# CITY OF NEWTON, MASSACHUSETTS

**To:** Zoning Board of Appeals Members  
**From:** Adrianna Henriquez, Clerk  
**Date:** June 23, 2021  
**Subject:** Materials for **June 28, 2021** Public Hearing

**Responses to Provide to ZBA Members, City Councilors, Planning Department, Horsley  
Witten and Engineering Department**  
**June 22, 2021**

**DATE:** June 23, 2021  
**TO:** Zoning Board of Appeals  
**FROM:** Urban Design Commission  
**RE:** 1149, 1151, 1157, 1169, 1171-1173, 1179, and 1185 Washington Street, 32 and 34 Dunstan Street, 12, 18, 24, and 25 Kempton Place – “Dunstan East”  
**CC:** Barney Heath, Director of Planning and Community Development  
Jennifer Caira, Deputy Director  
Neil Cronin, Chief Planner  
Petitioner

# RADIAN BOLLARD

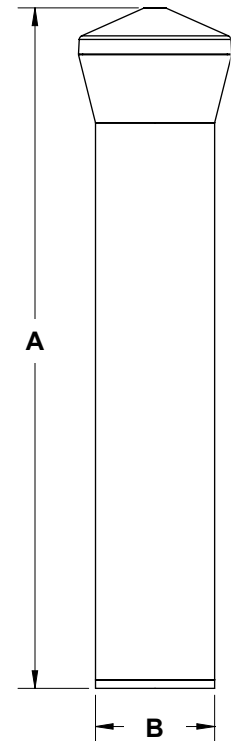
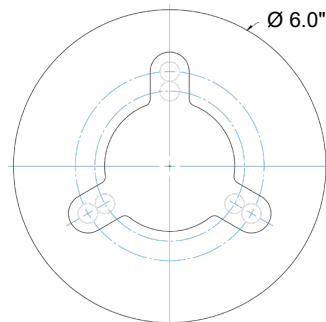
*35. Provide manufacturer sheets for the proposed fixtures, particularly for the "SL1" fixtures.*

See attached lighting cut-sheets for the three fixtures shown on the plan.

SECTION DIAGRAM 1  
MAY 26, 2021

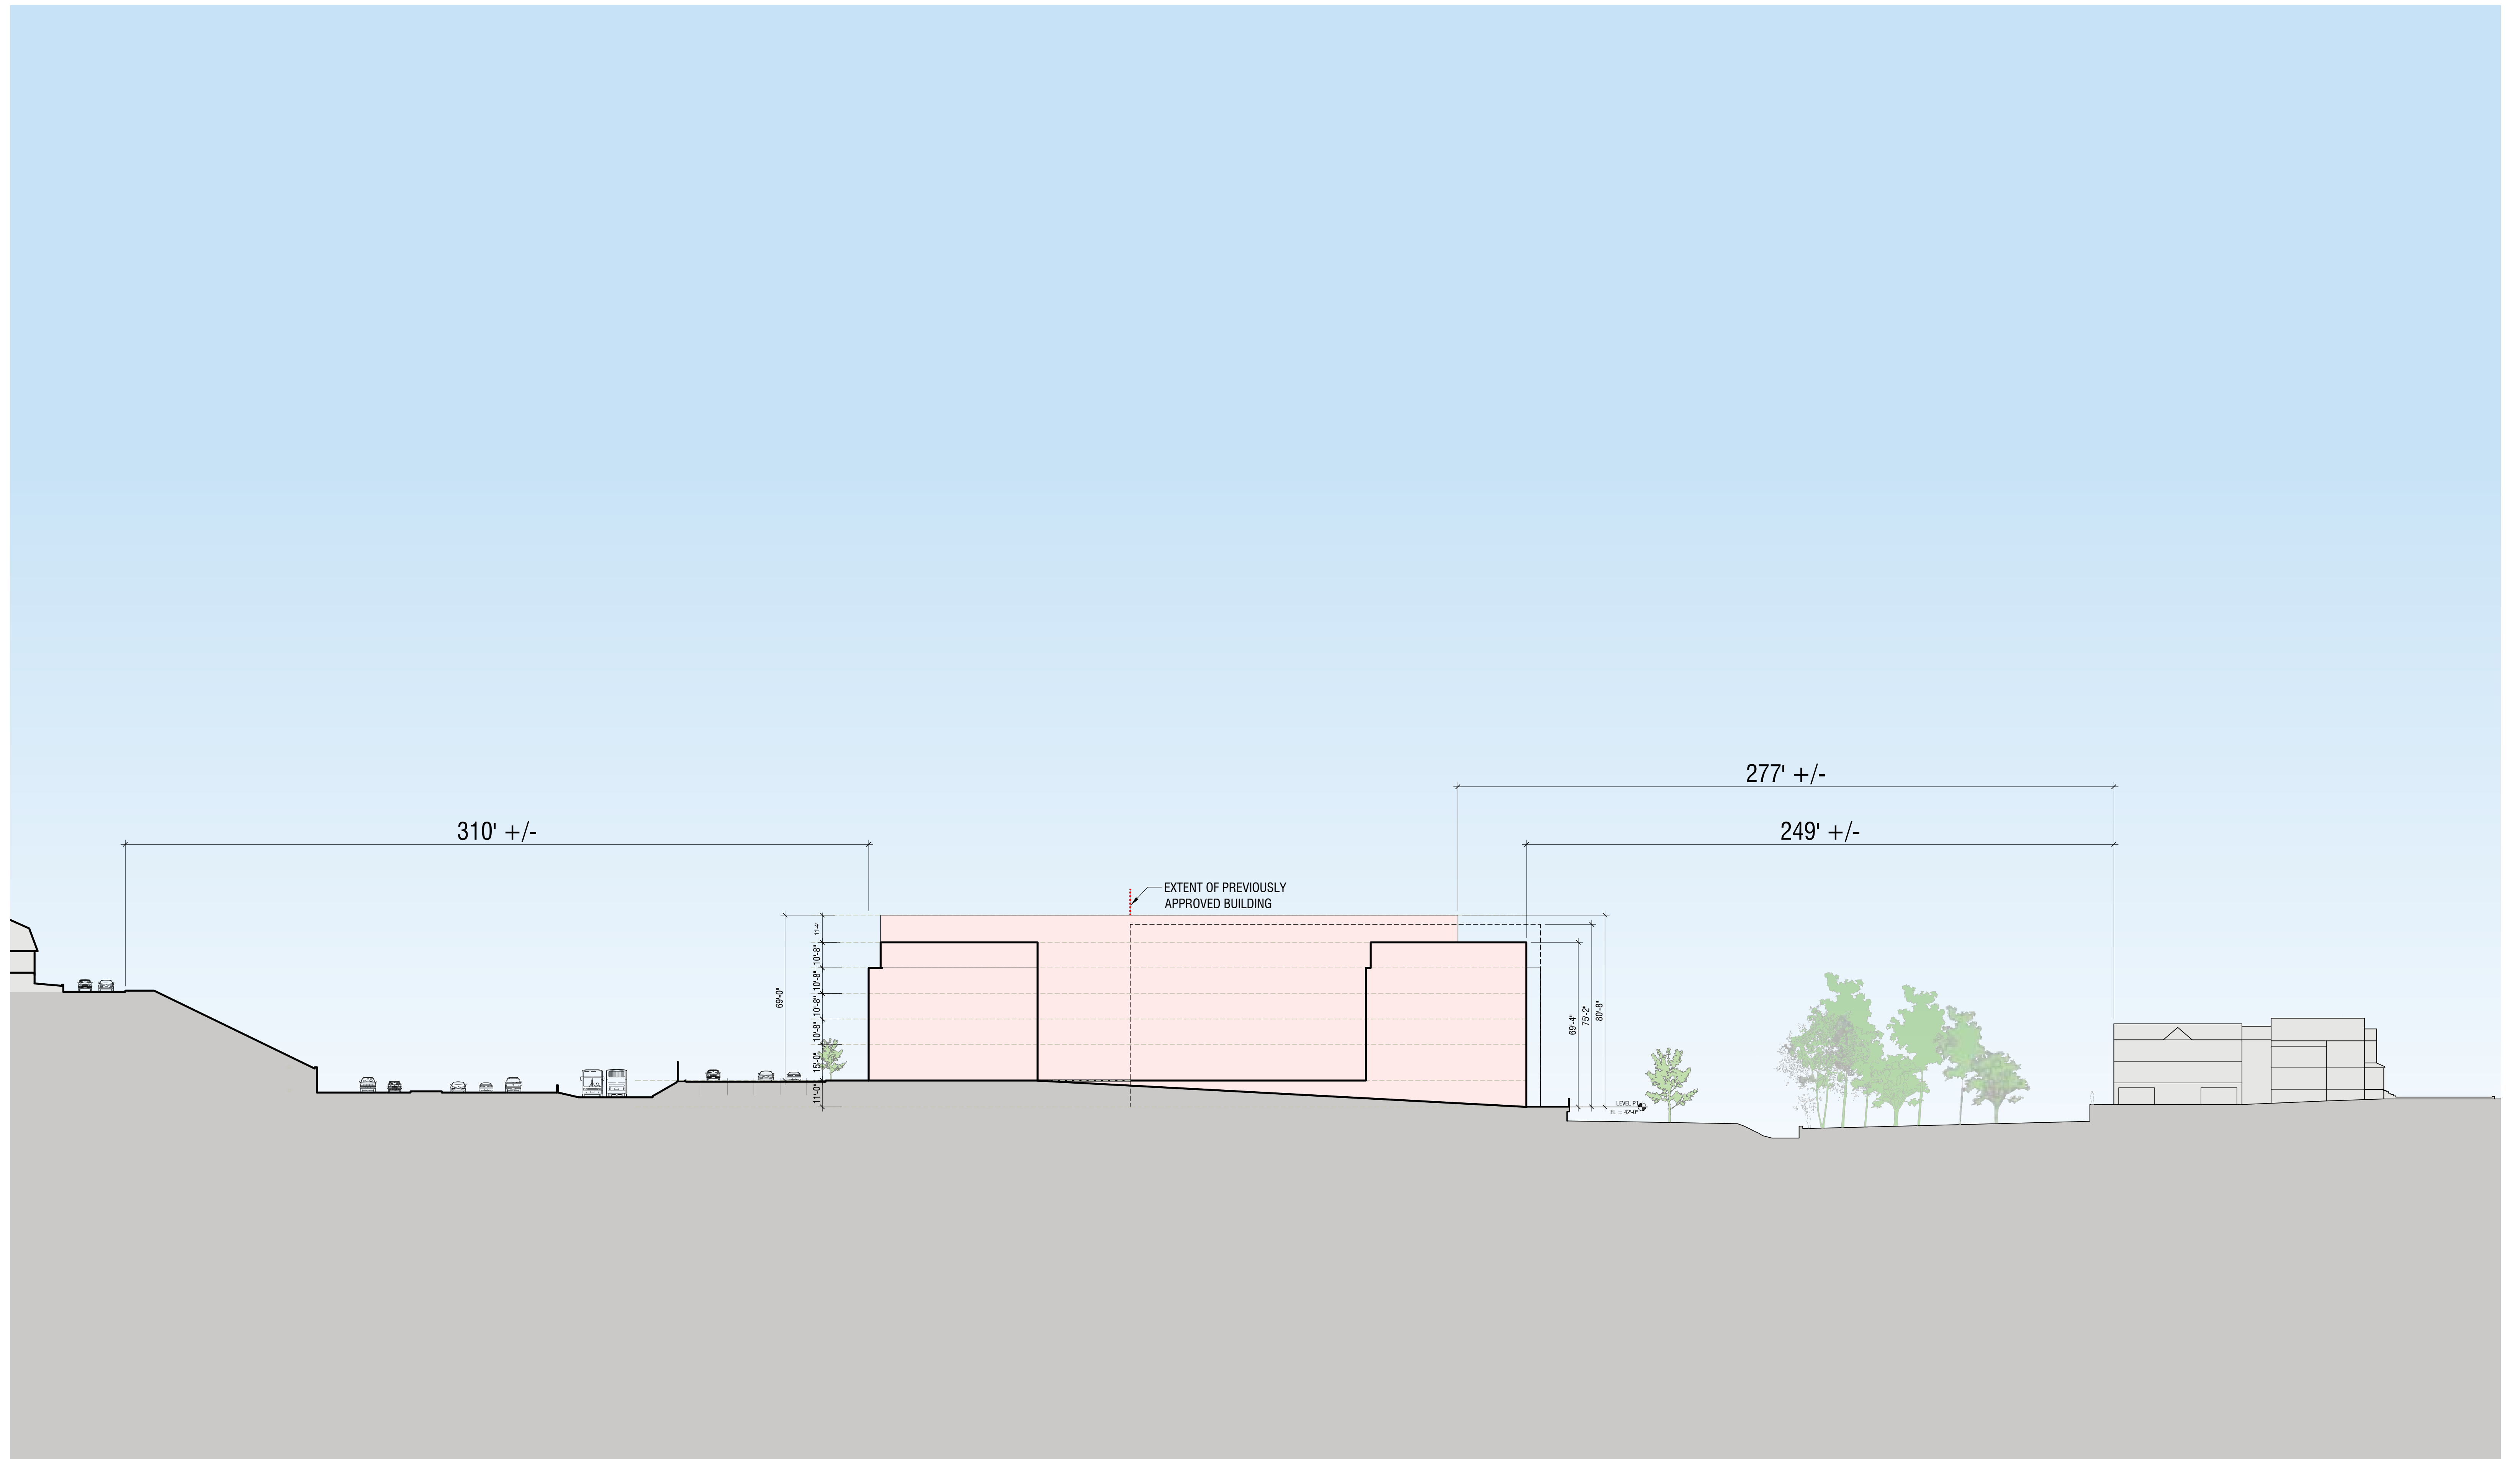
*22. Update previous exhibits and cross sections to reflect updated courtyard design.*

The updated exhibits and cross section were submitted in May and are attached hereto. See "Section Diagrams Through Newton Hill" dated May 26, 2021.

Drawing Title  
**L1.1 SITE MATERIALS**

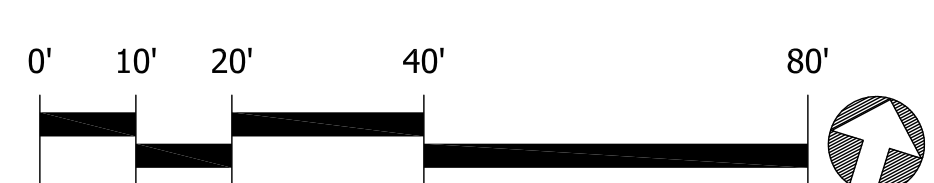
- 20. Provide detail relative to the different materials proposed for the entry to Building 3 garage and the sidewalk extending North towards Cheesecake Brook from this location.*

Sidewalk materials will be consistent along Dunstan Street and Kempton Place. They will consist of a permeable paver furnishing zone/tree way along the back of curb, a cast in place concrete pedestrian zone, and a buffer/planting zone along the building face (where space allows). A revised sheet L1.1 Site Materials plan is included with this submission.
